#### GENERAL COMMENT FOR ALL DWGS:

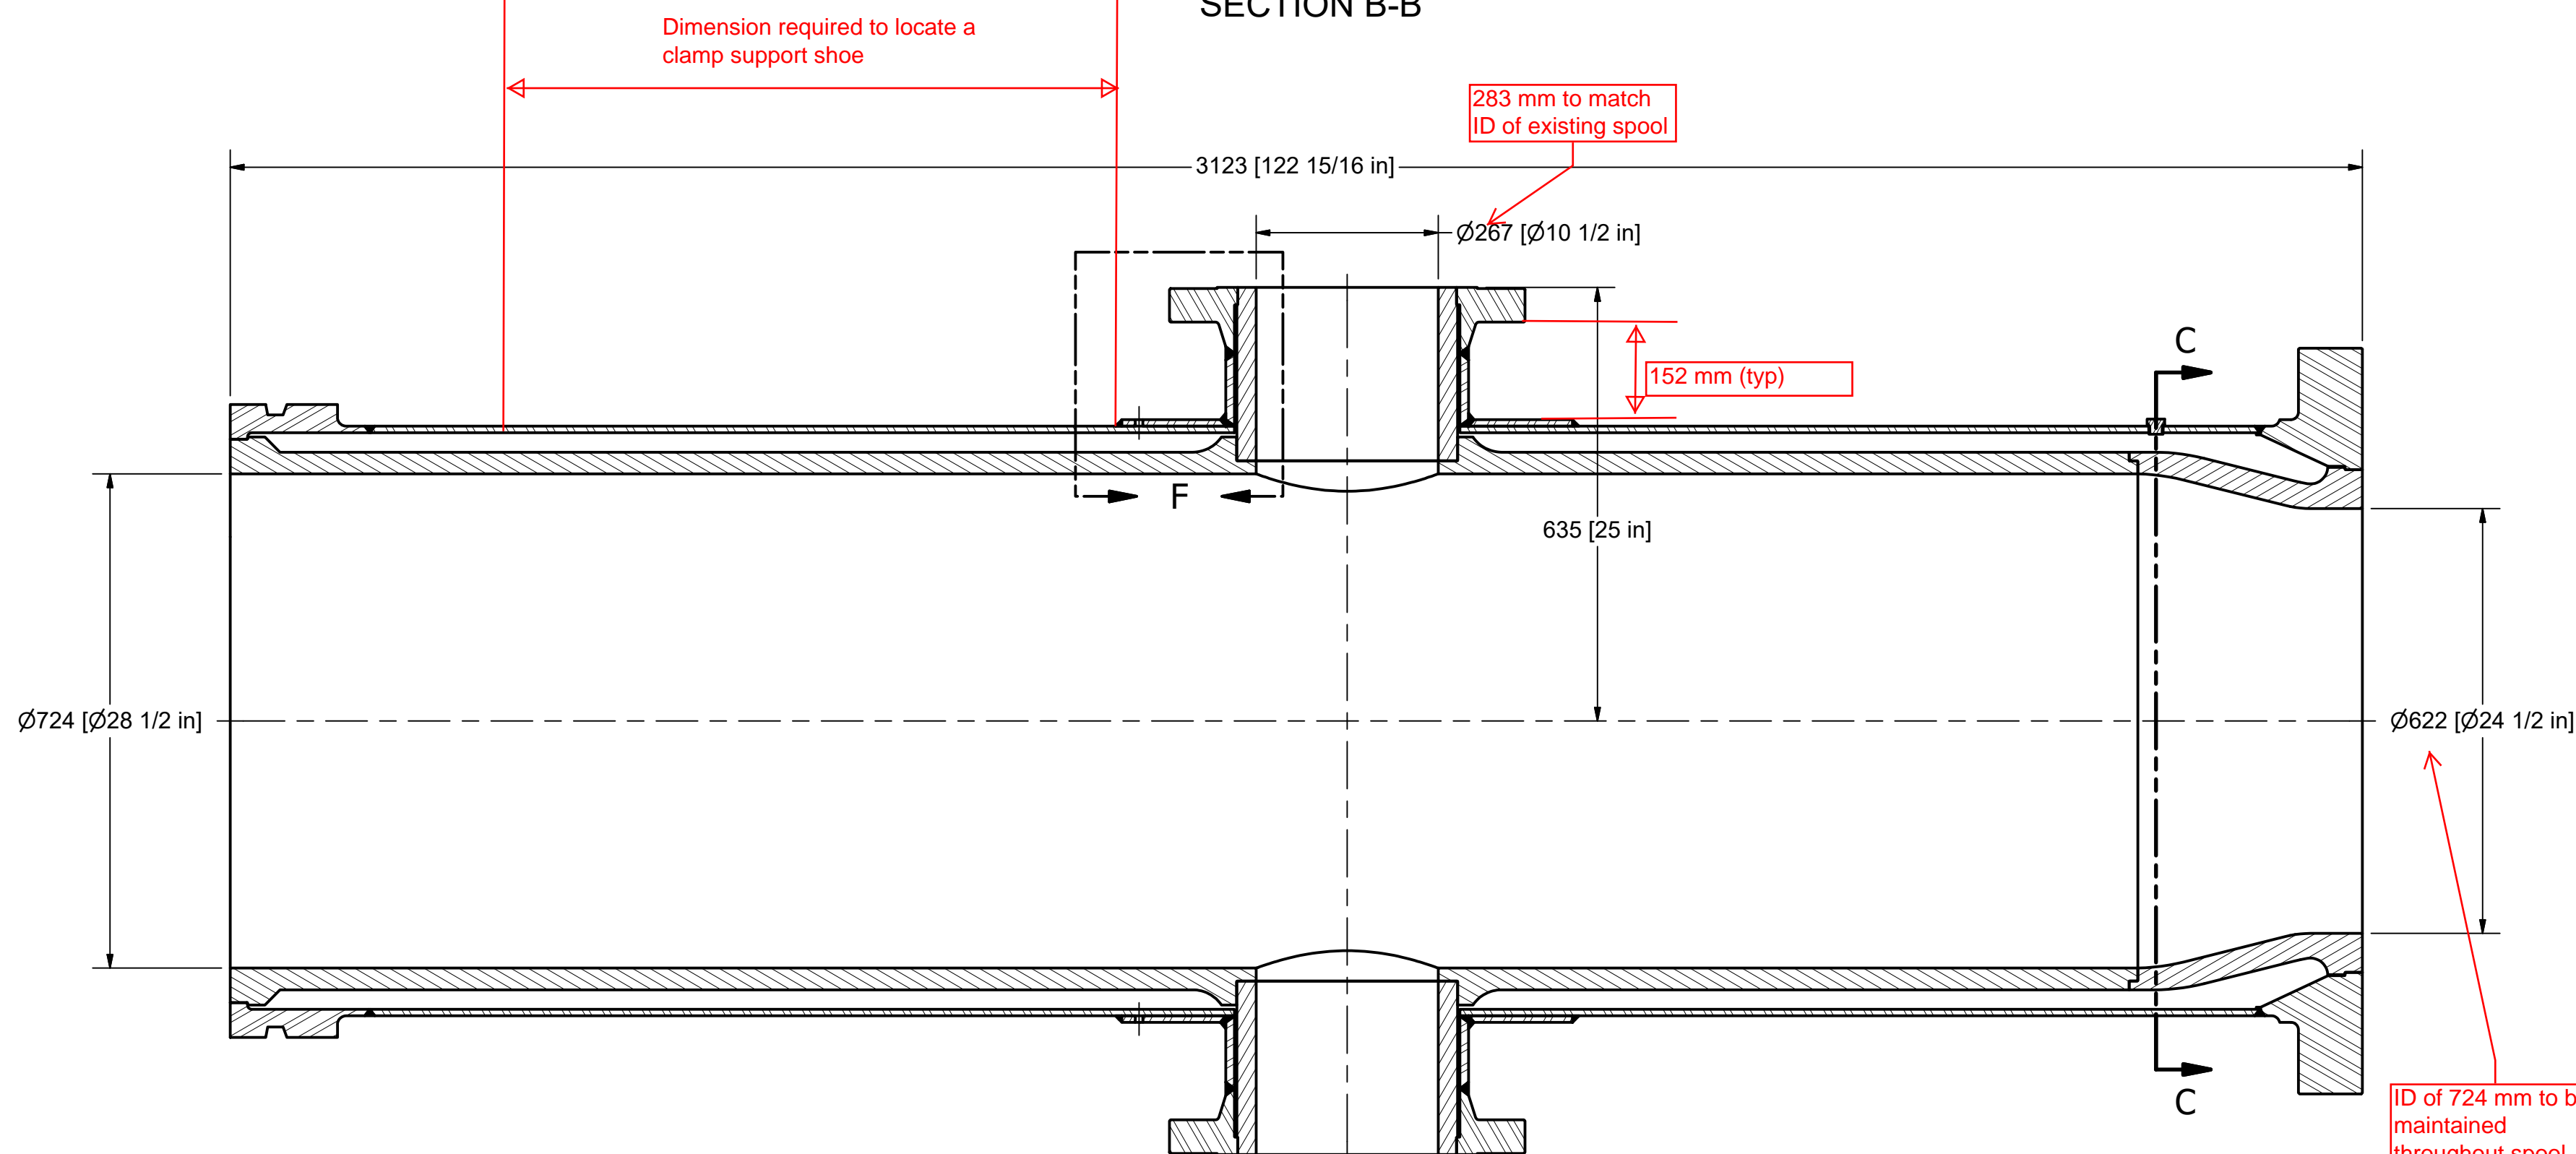
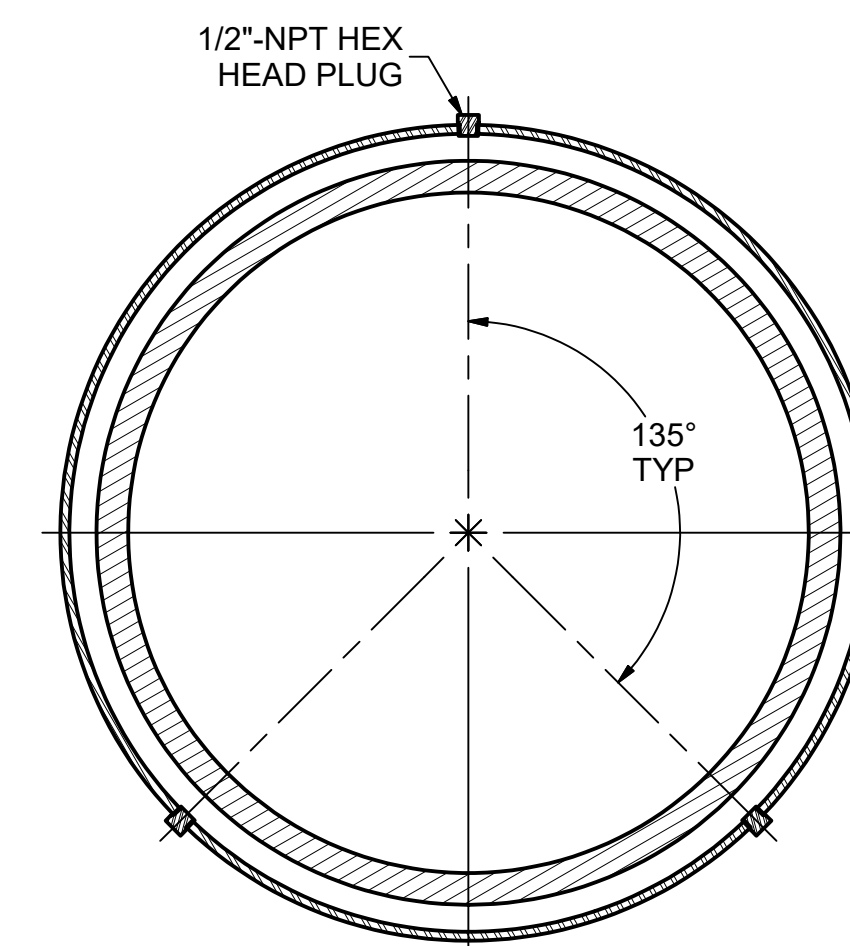
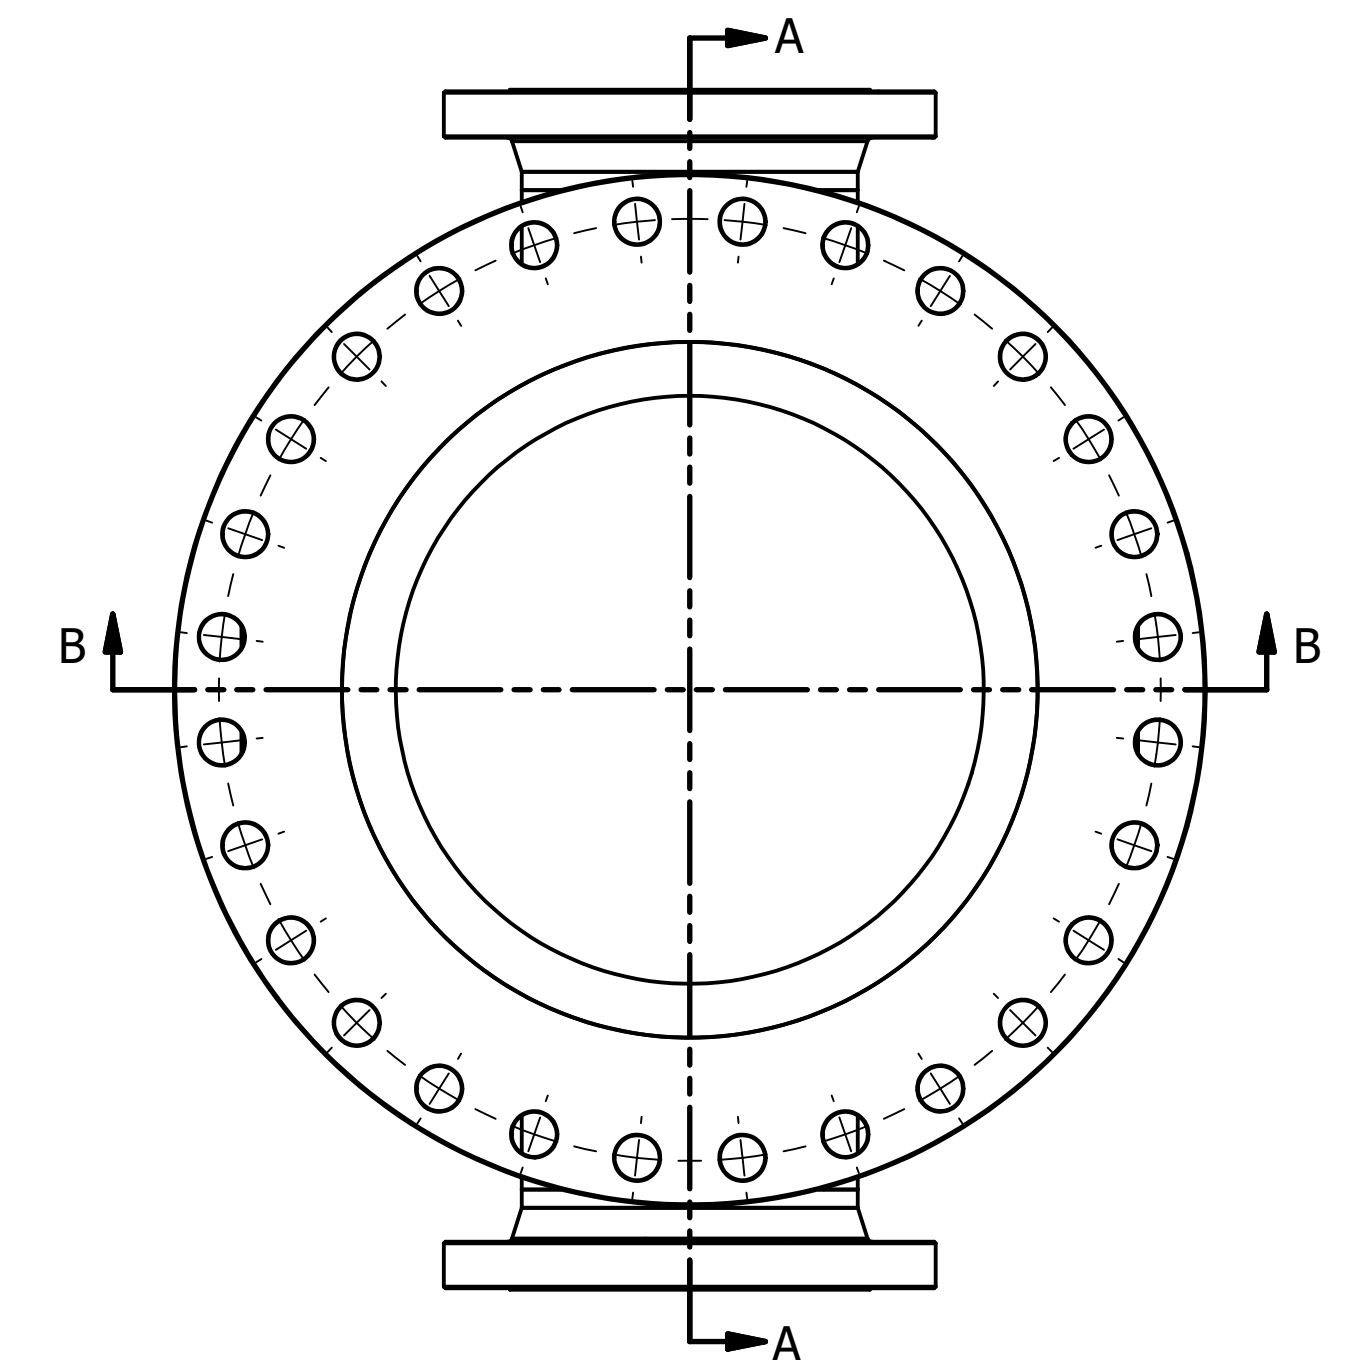
Note: Hydrotest pressure of this spool has been updated to 7665 Kpag
